SUBJECT: ISSUANCE OF AMENDMENT NO. 84 TO FACILITY OPERATING LICENSE  
NO. NPF-21 - WPPSS NUCLEAR PROJECT NO. 2 (TAC NO. 76071)

SUBJECT: ISSUANCE OF AMENDMENT NO. 84 TO FACILITY OPERATING LICENSE  
NO. NPF-21 - WPPSS NUCLEAR PROJECT NO. 2 (TAC NO. 76071)

AMENDMENT TO FACILITY OPERATING LICENSE

Amendment No. 84  
License No. NPF-21

Figure 3.2.1-7

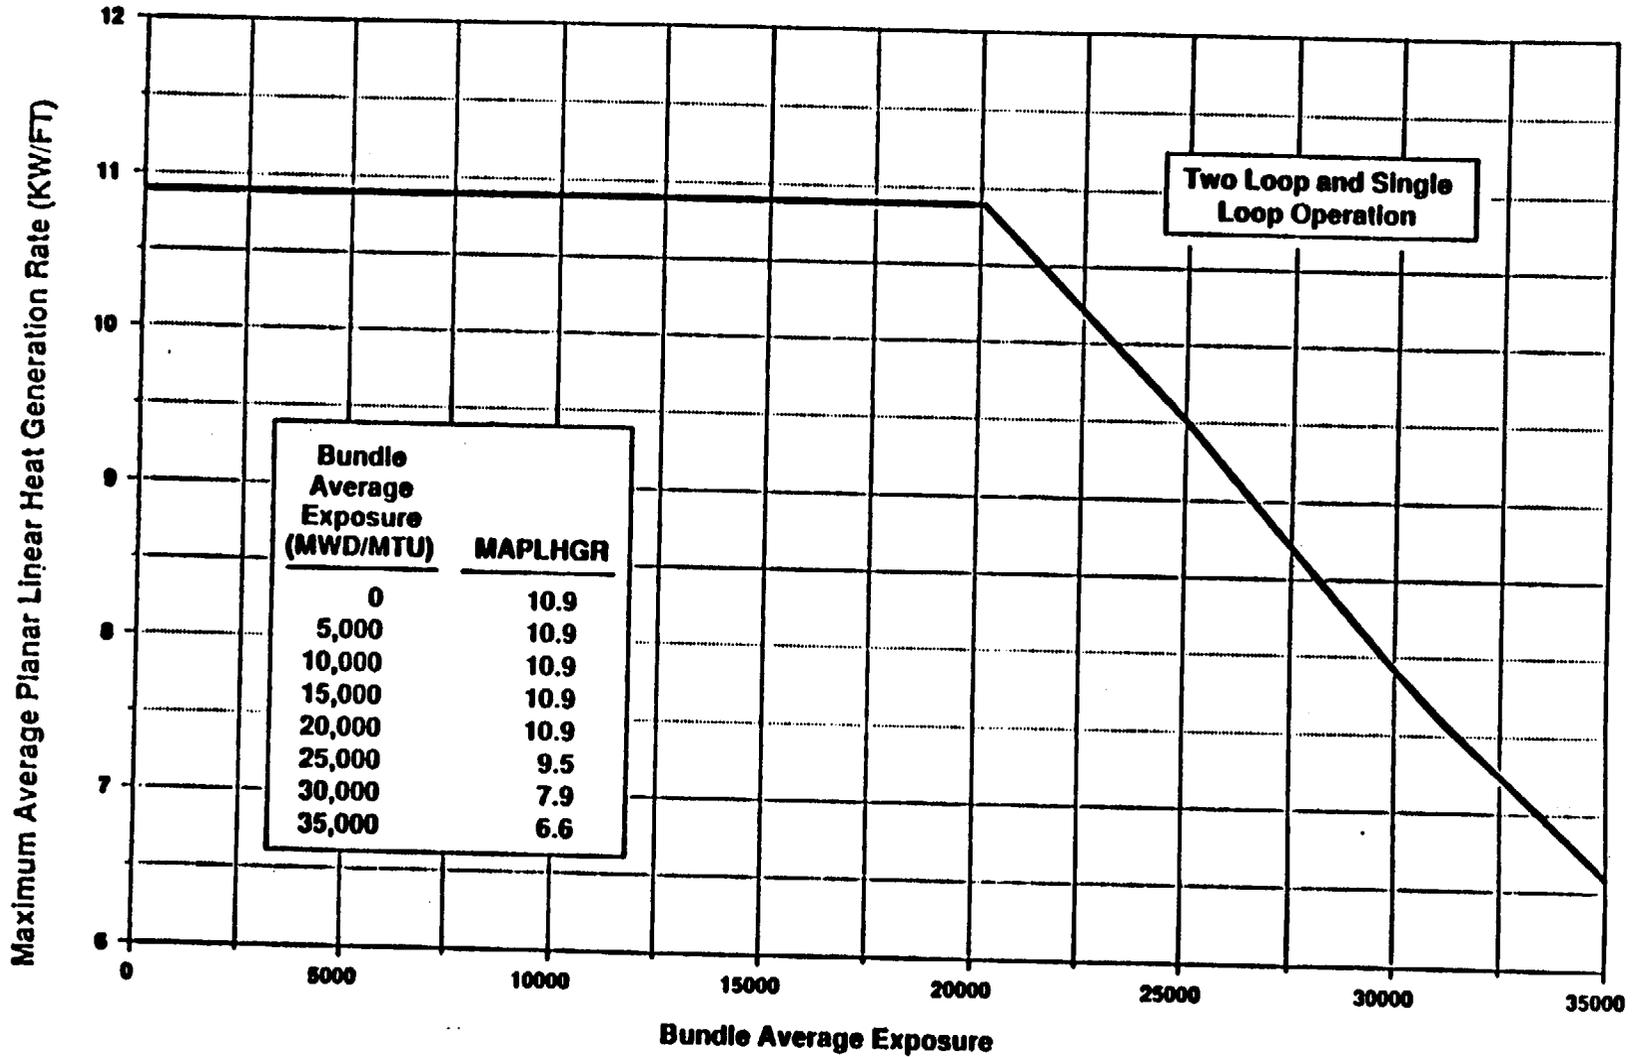
3.2.1 All AVERAGE PLANAR LINEAR HEAT GENERATION RATES (APLHGRs) for each type of fuel as a function of AVERAGE PLANAR EXPOSURE for GE initial core fuel and average bundle exposure for ANF, SVEA-96 and GE11 LFA fuel shall not exceed the limits shown in Figures 3.2.1-1, 3.2.1-2, 3.2.1-3, 3.2.1-6, 3.2.1-7 and 3.2.1-8 when in two loop operation, and Figures 3.2.1-3, 3.2.1-4, 3.2.1-5, 3.2.1-6, 3.2.1-7 and 3.2.1-8 when in single loop operation.

This specification and basis are being changed to incorporate MCPR values for the ANF 8x8C and the SVEA-96 LFAs that reflect the Cycle 6 transient analyses including the FFWR option. The GE 8x8 reload fuel, the ANF LFAs, and the GE11 LFAs will be monitored to the ANF 8x8C MCPR limits. In addition, the title of Figure 3.2.3-1 (MCPR Operating Limit versus Total Core Flow) is changed. These changes are acceptable.

**Reduced Flow MCPR Operating Limit**  
This Curve is Applicable to ANF Reload Fuel, GE Initial Core Fuel,  
ANF 9 X 9 LFA Fuel, GE 11 LFA Fuel, and SVEA-96 LFA Fuel  
This curve is also applicable to FFTR operation  
Figure 3.2.3-1

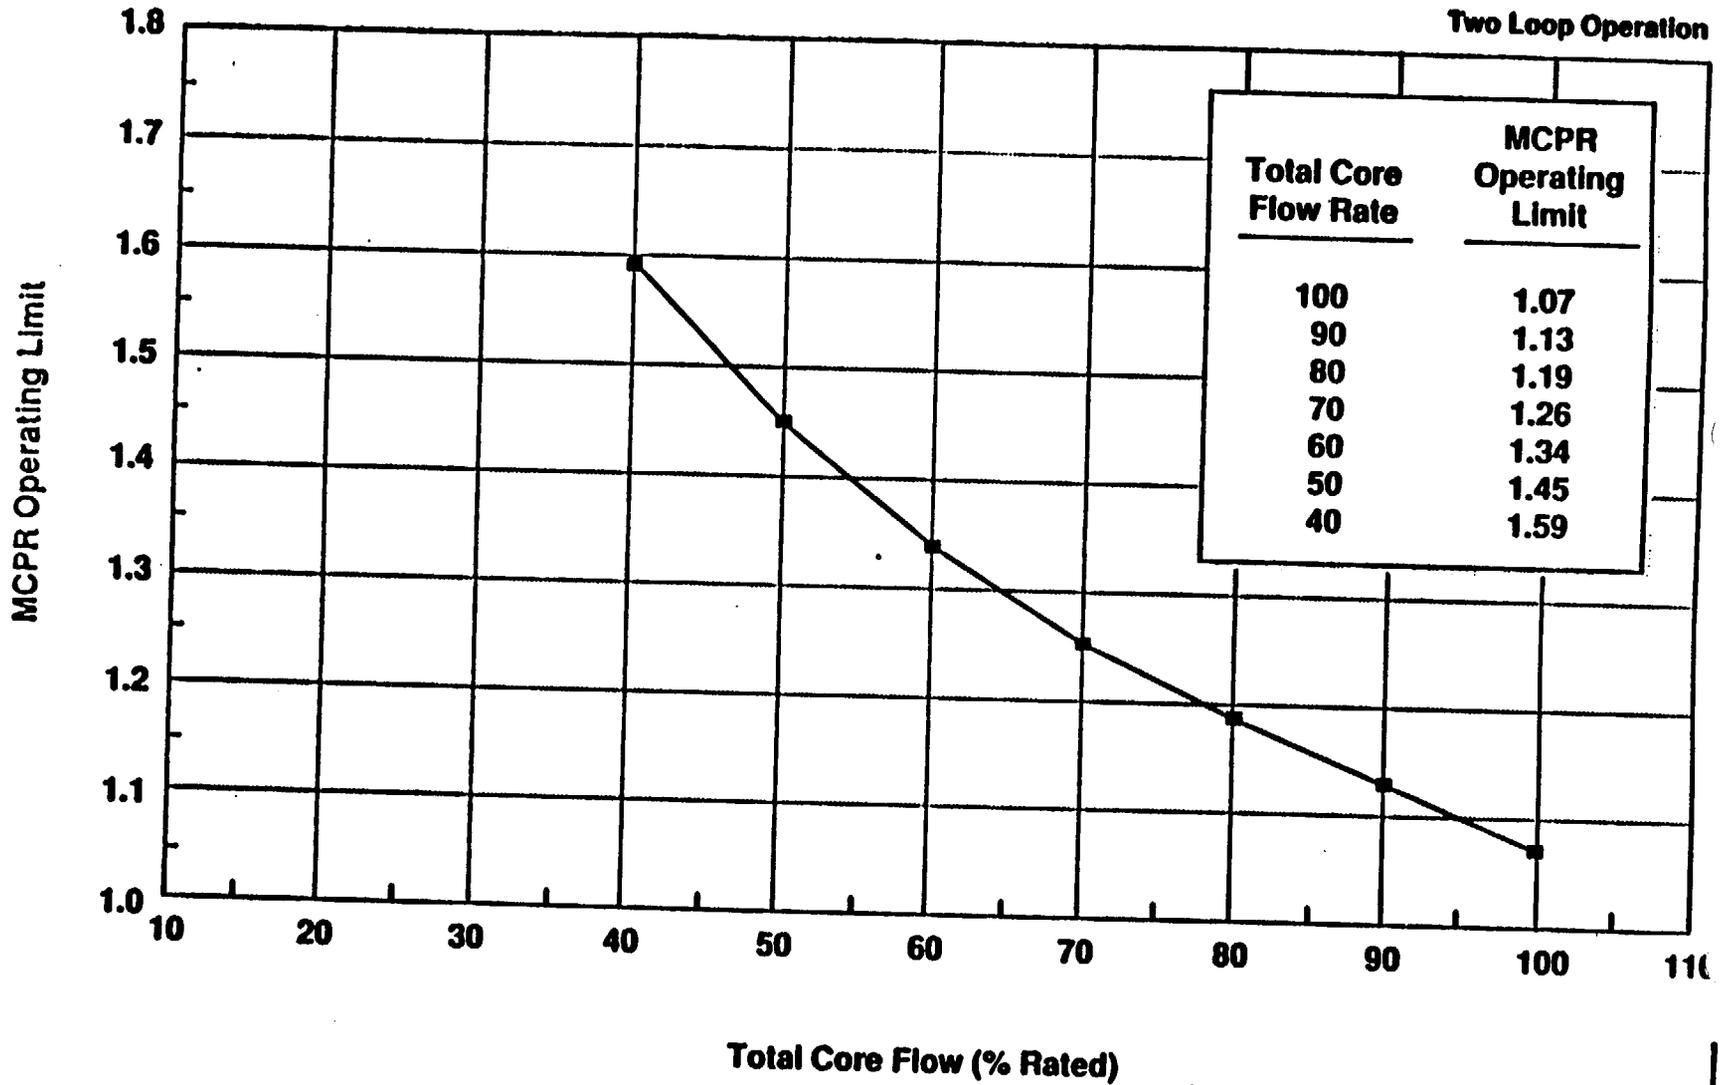
The purpose of the  $MCPR_f$  of Figure 3.2.3-1 is to define operating limits at other than rated core flow conditions. At less than 100% of rated flow the required MCPR is the maximum of the rated flow MCPR determined from Table 3.2.3-1 and the reduced flow MCPR determined from Figure 3.2.3-1,  $MCPR_f$  assures that the Safety Limit MCPR will not be violated.  $MCPR_f$  is only calculated for the manual flow control mode. Automatic flow control operation is not permitted.

Figure 3.2.4-4

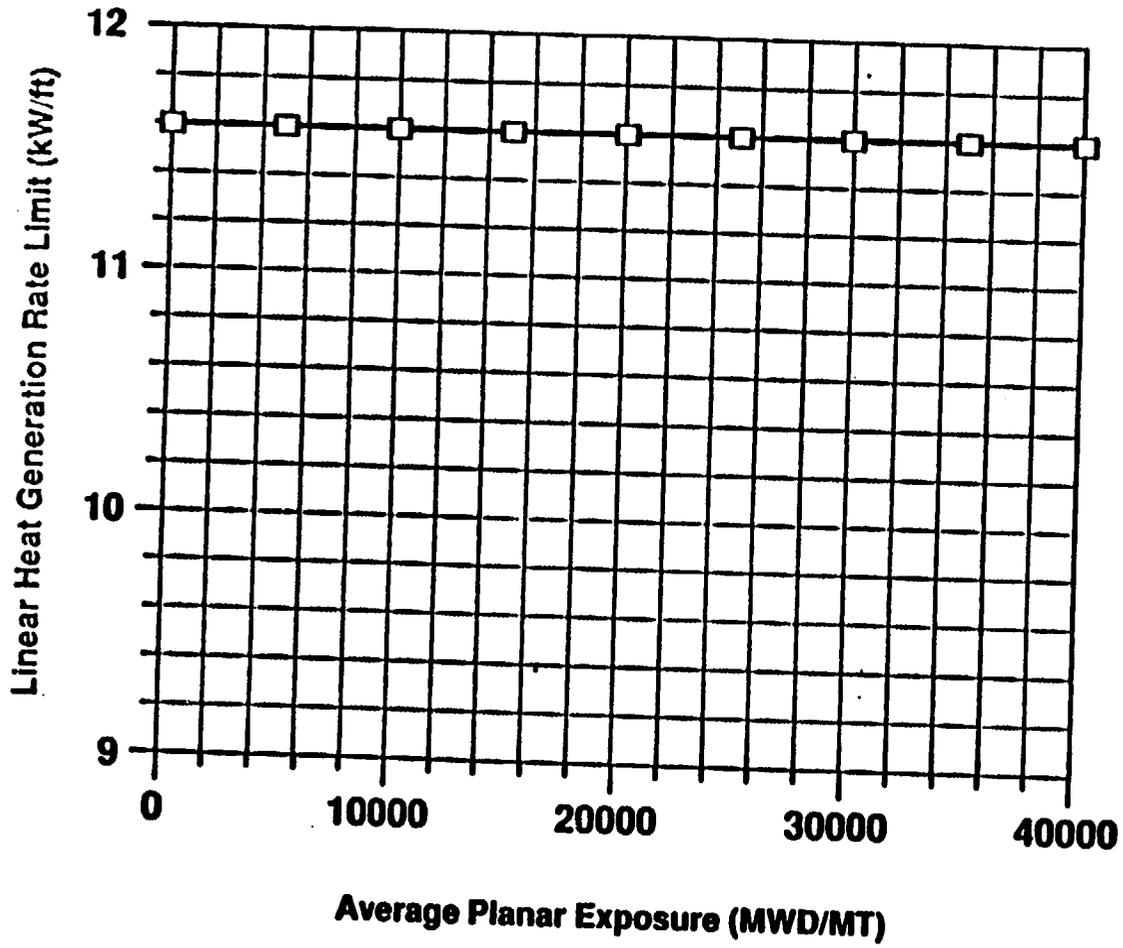
3.2.4 The LINEAR HEAT GENERATION RATE (LHGR) for GE initial core fuel shall not exceed 13.4 kW/ft. The LHGR for reload fuel shall not exceed the values shown in Figures 3.2.4-1, 3.2.4-2, 3.2.4-3, 3.2.4-4 and 3.2.4-5.

This specification is changed to include the LHGR limits for the GE11 LFAs and SVEA-96 LFAs. This change is acceptable.
